GB 2003-28
PHASE 3 FINAL PROCEEDING
BITUMEN CONSERVATION
REQUIREMENTS

RESPONSE SUBMISSION
MAY 9, 2005

PROCEEDING NO.
1347905

NEXEN INC.

Figure 1: Core photographs demonstrating “Regular meandering (*Helminthoida*) or irregular meandering (*Helminthopsis*), smooth-walled burrows” on horizontal section of core, from Pemberton *et al*; page 298 (top photo) and page 299 (bottom photo).

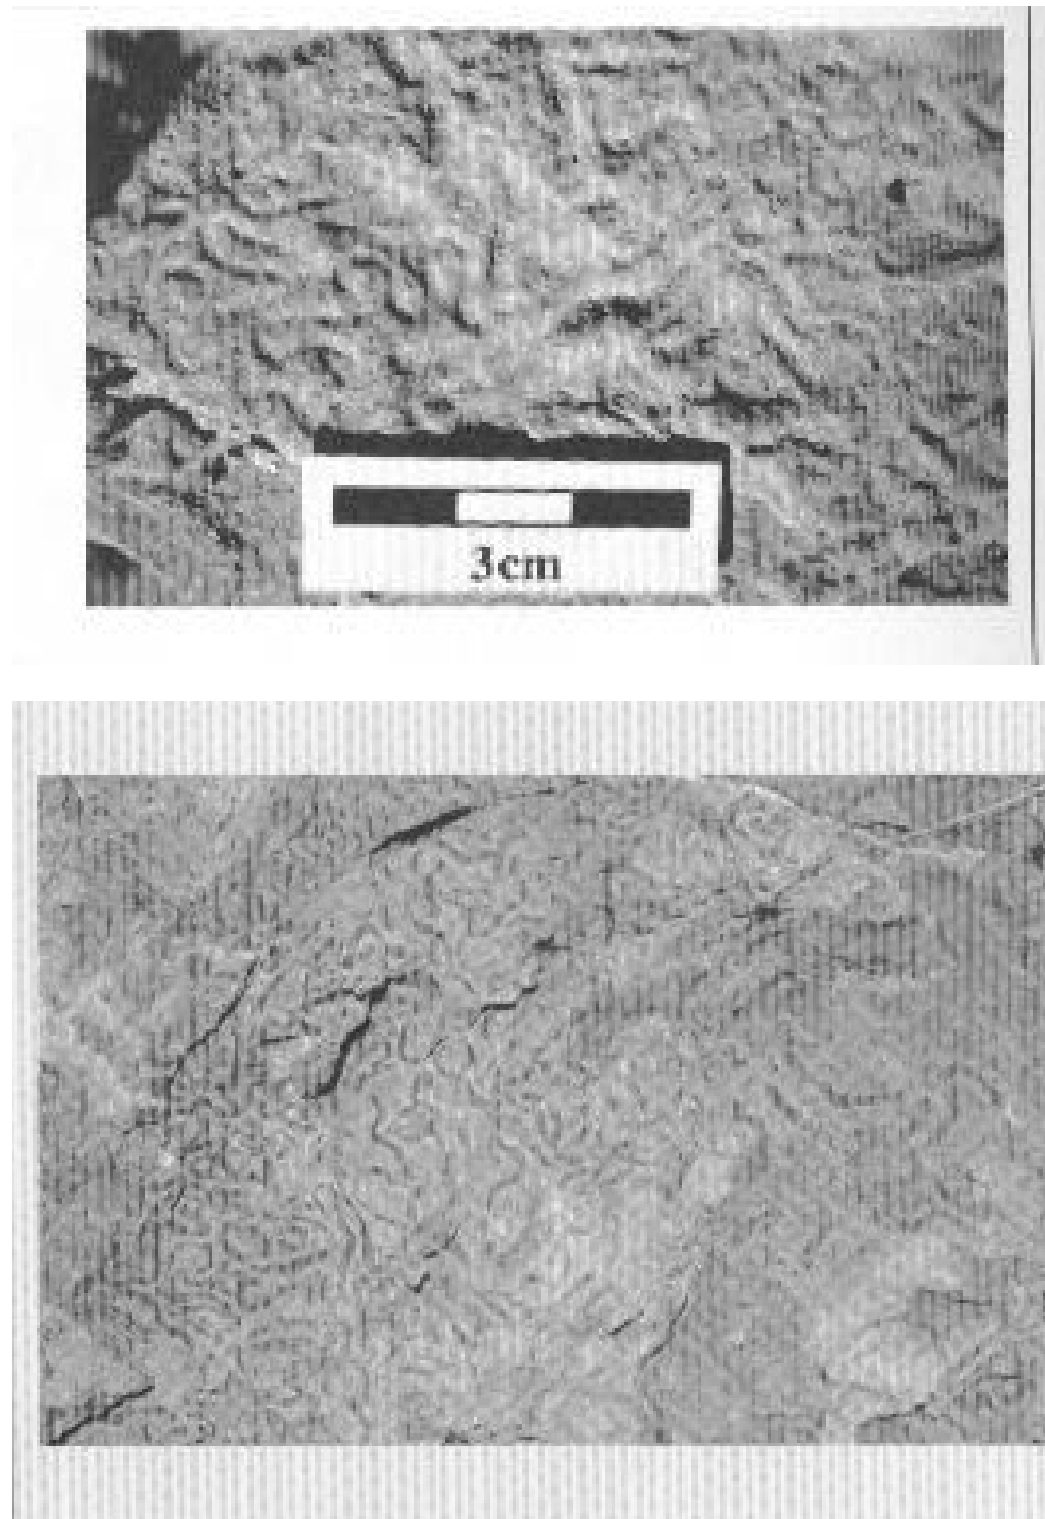
The trace fossil *Helminthopsis* is considered to be a common element of the trace fossil assemblages that are characteristic of normal marine shallow shelf environments². Within the McMurray cores examined in the context of its simulations, PEOC interprets “marine mud” intervals with “dominantly *Teichichnus* and *Helminthopsis*” trace fossil assemblages. The implication of this interpretation is a more prevalent marine influence in the McMurray Formation than found to date in the previous submissions of Nexen or in the RGS.

Regular meandering (*Helminthoida*), or irregularly meandering (*Helminthopsis*), smooth-walled burrows which never branch, interpenetrate or cut across one another. In cross-section, the burrows are elliptical to sub-circular and are generally horizontal. Fill tends to be dissimilar from the surrounding matrix. In core, *Helminthoida/Helminthopsis* commonly appears as tiny dark spots (transverse section) 1 – 3 mm in diameter, or dark lines (longitudinal sections).

The following figures are reproduced from the same reference to illustrate the above description of the meandering character of the burrows as seen in horizontal section:
